HISTORIC AND DESIGN REVIEW COMMISSION

HDRC CASE NO: 2021-271
ADDRESS: 101 PASO HONDO
LEGAL DESCRIPTION: NCB 591 BLK 4 LOT 13
ZONING: RM-4, H
CITY COUNCIL DIST.: 2
DISTRICT: Dignowity Hill Historic District
APPLICANT: George Torres III/George Torres Architect
OWNER: Brett Cohen/JRB CAPITAL LLC
TYPE OF WORK: Construction of two, 2-story residential structures
APPLICATION RECEIVED: May 27, 2021
60-DAY REVIEW: Not applicable due to City Council Emergency Orders
CASE MANAGER: Edward Hall

REQUEST:

The applicant is requesting conceptual approval to construct two, 2-story residential structures on the vacant lot at 101 Paso Hondo, located within the Dignowity Hill Historic District. This lot is located at the corner of Paso Hondo and N Mesquite.

ORIGINAL SITE PLAN

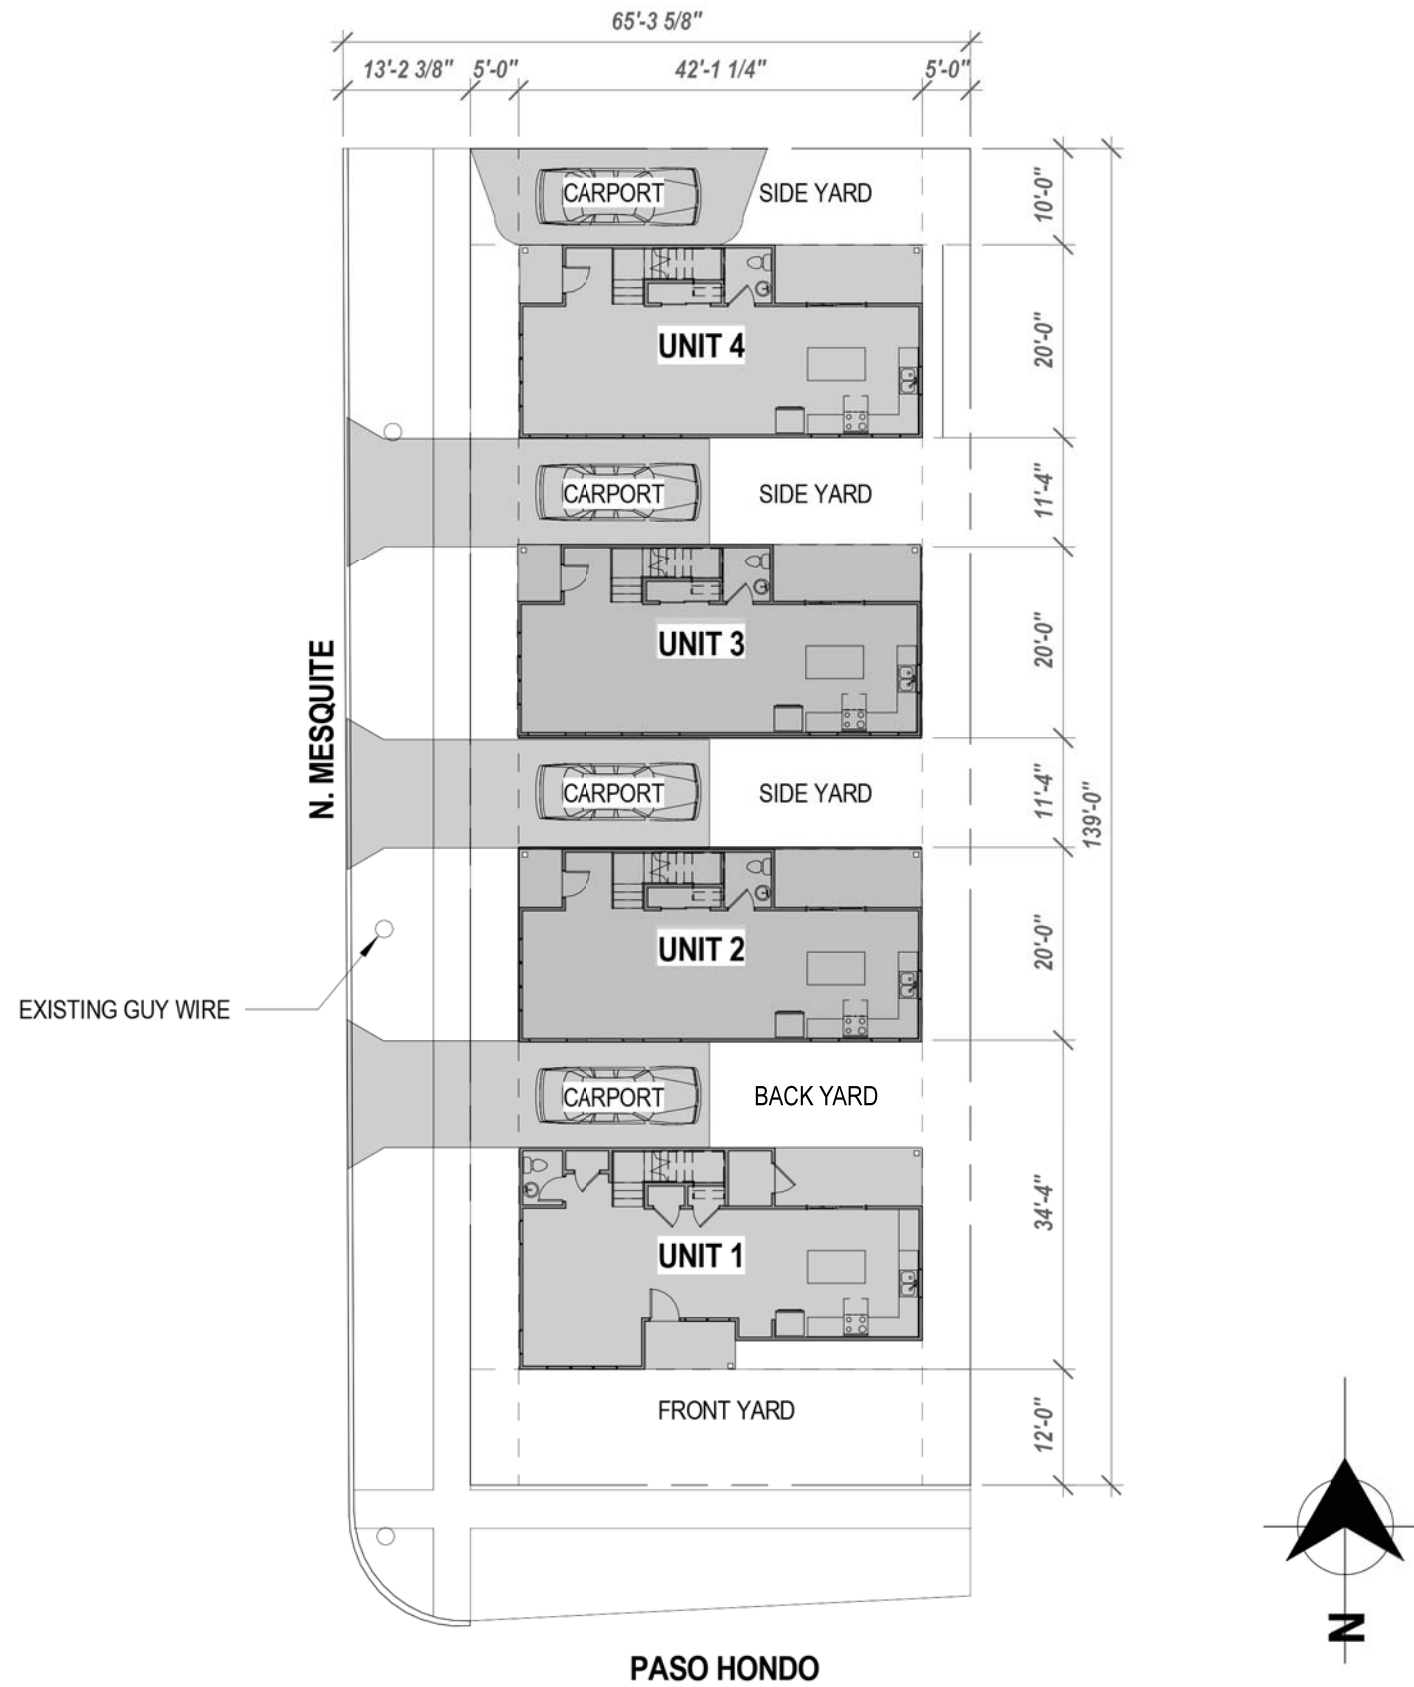
JF: Is there any separation between the carport of one house and the adjacent property? Does this meet development code (As currently proposed). (GT: Approximately one foot of separation, will be steel to meet building code). Roofs will be corrugated metal, sloped toward the front – towards N Mesquite.

MS: Can you clarify what the rear setback is (GT: Currently five feet at rear, ten feet on alley, and approximately twelve at front).

JF: Identify all setbacks on site plan.

UPDATED SITE PLAN

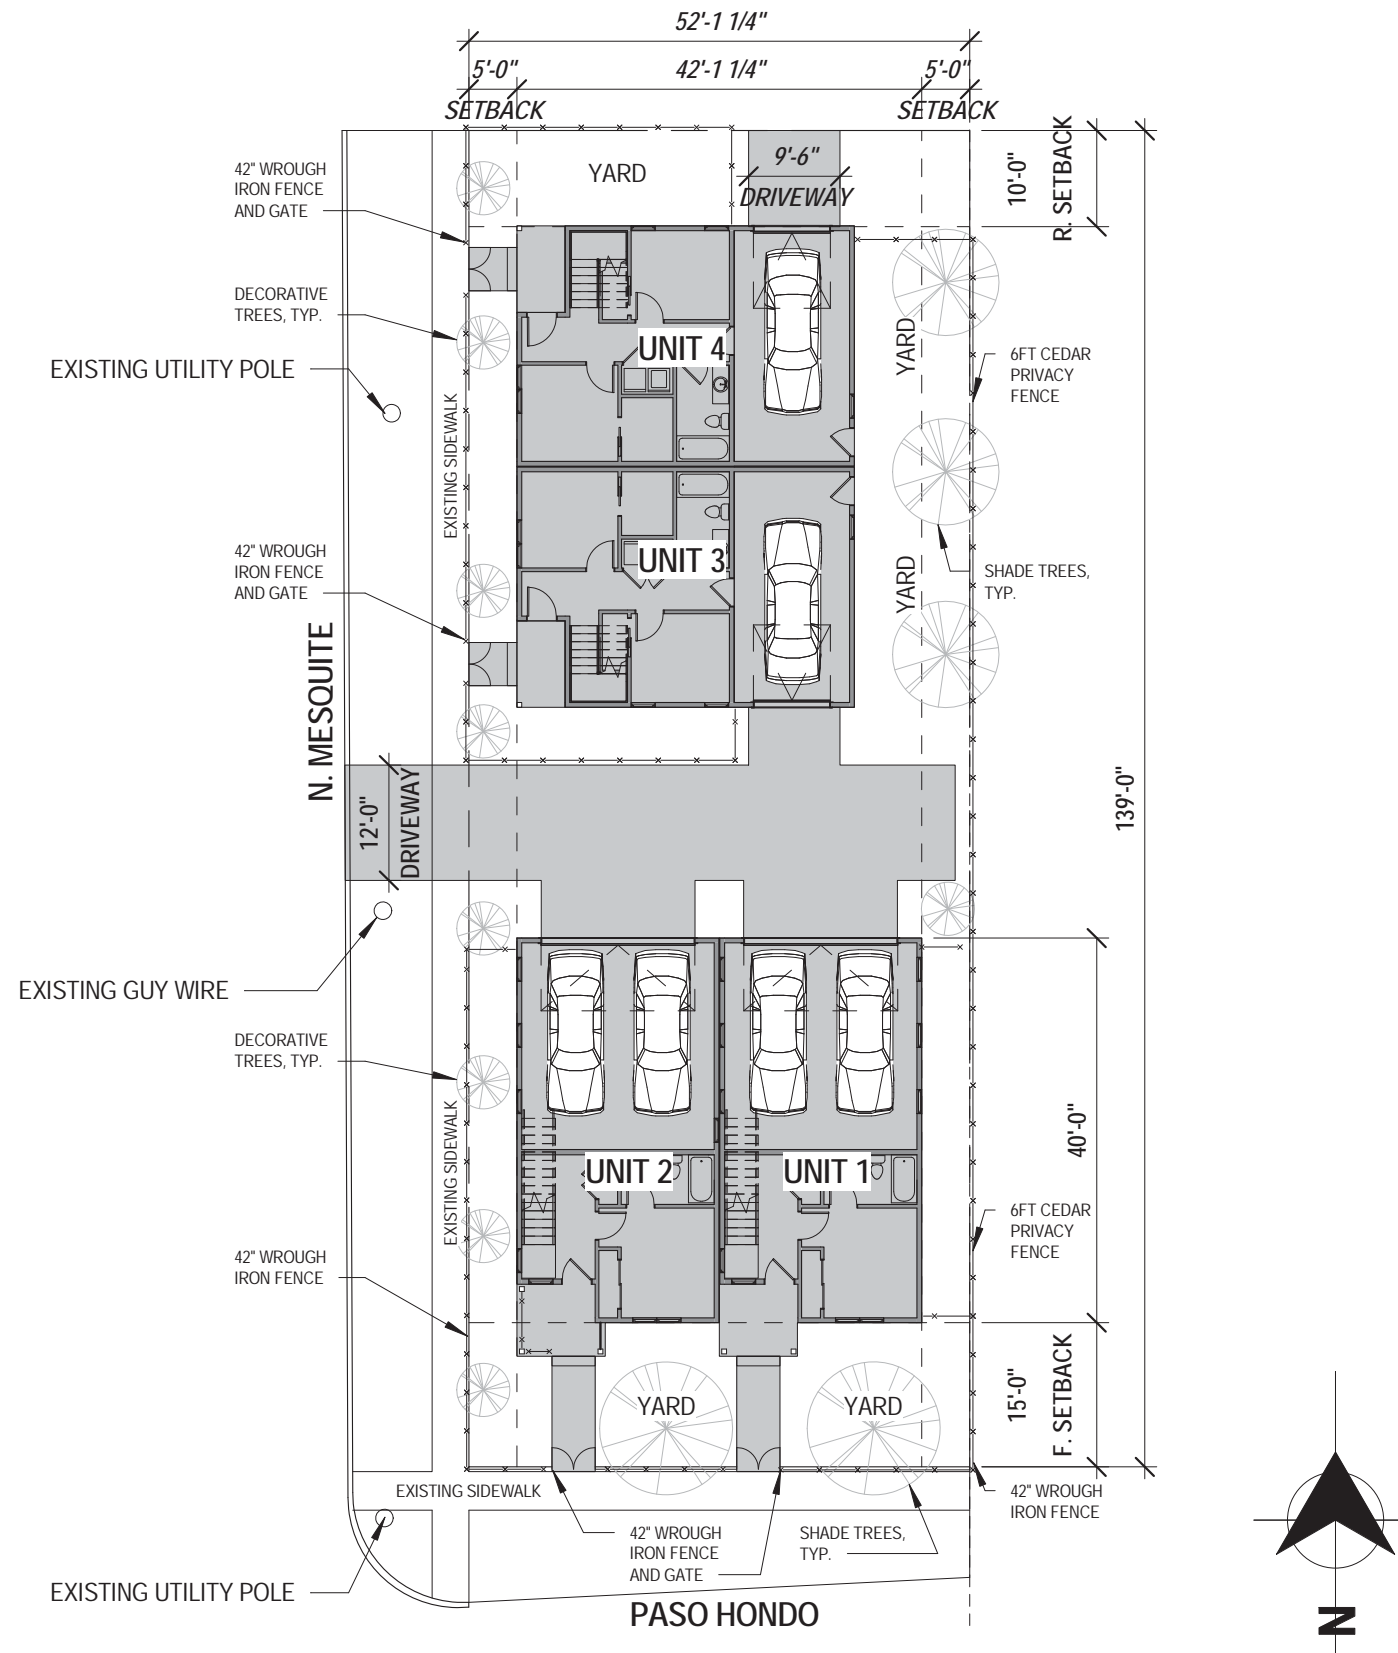
- e. **SETBACKS & ORIENTATION** – The applicant has noted a front setback on Paso Hondo of fifteen (15) feet, which is the setback of the neighboring historic structure. Given the proposed massing of the new construction staff finds that an increased setback would be most appropriate.

- m. **BUILDING SPACING** – The applicant has provided a site plan noting proposed setbacks and building spacing that is generally consistent with that which is found historically within the Dignowity Hill Historic District.

- q. DRIVEWAYS – The applicant has proposed for one driveway to be located on N Mesquite with additional vehicular access at the rear alley. The Guidelines for Site Elements note that driveways should not exceed ten (10) feet in width. While this driveway may provide vehicular access into the site for multiple tenants, staff finds that the proposed driveway should feature the narrowest width possible. Generally, staff finds the proposed width of twelve (12) feet to be appropriate.

JF: Include site elements, including fencing on the site plan.

- i. That the applicant increase the front setback on Paso Hondo to result in a setback that is greater than that of the adjacent, historic structure.
- ii. That the applicant incorporate street facing entrance elements on N Mesquite for the northern structure, as noted in finding h.
- iii. That square, fixed windows be eliminated from the design on facades visible from the right of way.
- iv. That the proposed materials adhere to the standards noted in finding n, and that window materials adhere to the standards noted in finding o and in the applicable citations.
- v. That the internal parking be eliminated, as noted in finding r.
- vi. That all mechanical equipment be screened from view from the public right of way as noted in finding t.
- vii. That the applicant continue to develop porch elements that reflect porch massing found historically within the district.

PROPOSED MATERIALS

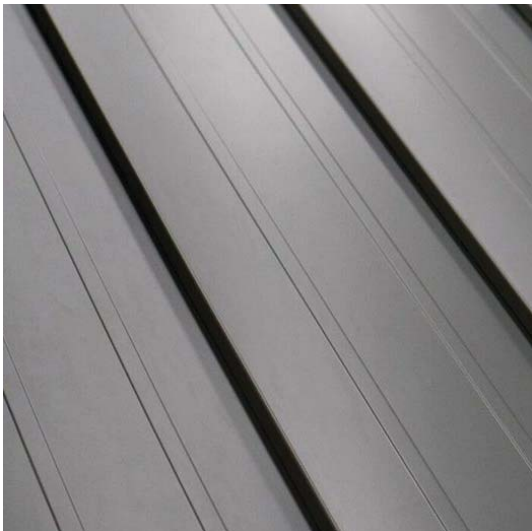
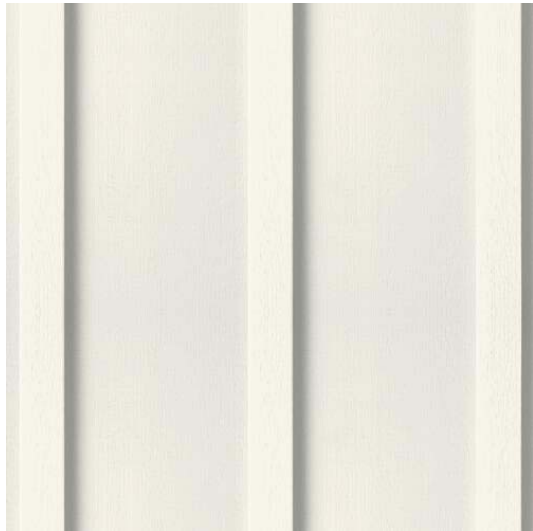
- n. **MATERIALS** – The applicant has noted the installation of standing seam metal roofs, composite siding, steel entry doors, lap siding and board and batten siding. Staff finds that all standing seam metal roof should feature seams that are 1 to 2 inches in height, panels that are smooth and 18 to 21 inches in width, a standard galvalume finish, and a crimped ridge seam or low profile ridge cap. Additionally, staff finds that all horizontal siding should feature smooth panels with a 4 inch exposure and a thickness of $\frac{3}{4}$ of an inch. Regarding board and batten siding, staff finds that all boards should be 12 inches in width with battens that are approximately 1.5 inches in width. Smooth composite siding should be used throughout.

- o. **WINDOW MATERIALS** – The applicant has noted the installation of aluminum clad wood windows. Staff finds that product specifications should be submitted to staff for review and approval that are consistent with staff's standard specifications for windows in new construction.
